RE: H. B. ROBINSON UNIT NO. 2
DOCKET NO. 50-261
FACILITY OPERATING LICENSE NO. DPR-23

H. B. ROBINSON UNIT 2
CYCLE 4 RELOAD APPLICATION

Response to NRC Staff
Request for Additional Information

Figure 1: SCHEMATIC OF ONSET OF STABLE AND UNSTABLE FLOW CONDITIONS

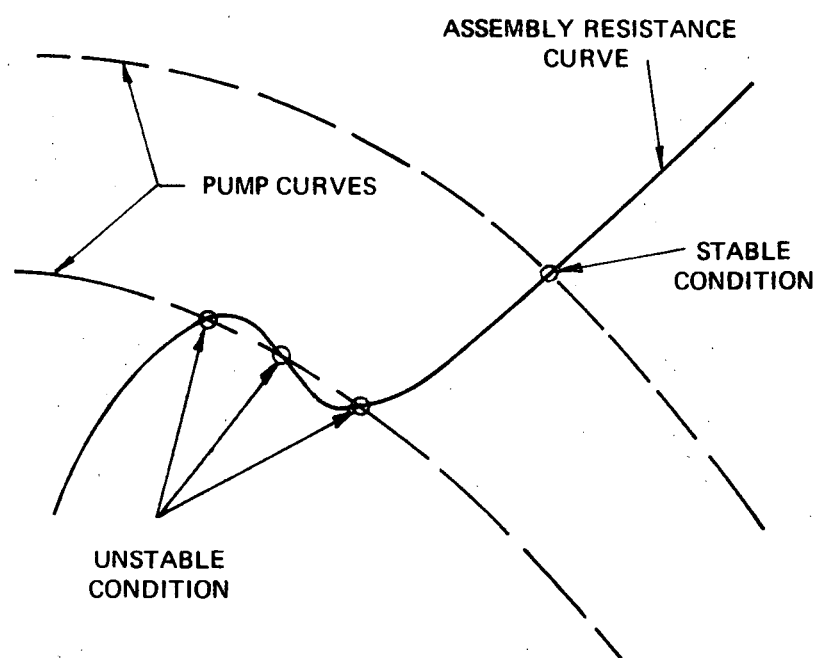
Provide a discussion of hydraulic core flow instability effects, which considers the flow resistance differences existing between ENC and Westinghouse fuel.

In order to assure stable thermal hydraulic operation of the H. B. Robinson reactor, a stability analysis was performed to determine the onset of flow instability and to show the margin between operating conditions and the onset of flow stability. A flow instability requires that the pump supply or demand curve cross the system resistance curve at more than one point. Figure 1 illustrates both the stable and unstable operating conditions. Since the pump curve in the reactor has a negative slope, the maintenance of a positive slope ($dP/dG > 0$) on the resistance curve over the operating range is sufficient to prevent a flow instability.
